YAMAHA

PARTS CATALOGUE

GOLF CAR

GOLF CAR 1985

G2-A/G2-E PRIMARY ID FRAME LOCATION CHANGE

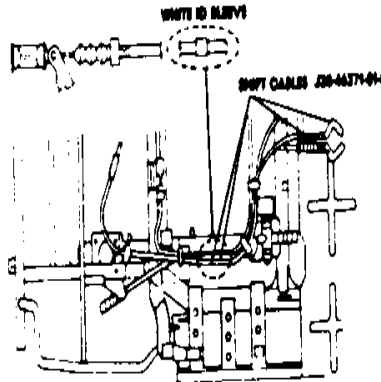
The improved shift cables will be crimped in YPDI block as soon as current supplies are depleted.

The part number of the improved cable remains the same. However, a white sleeve has been placed around the outer cable to identify the improved version.
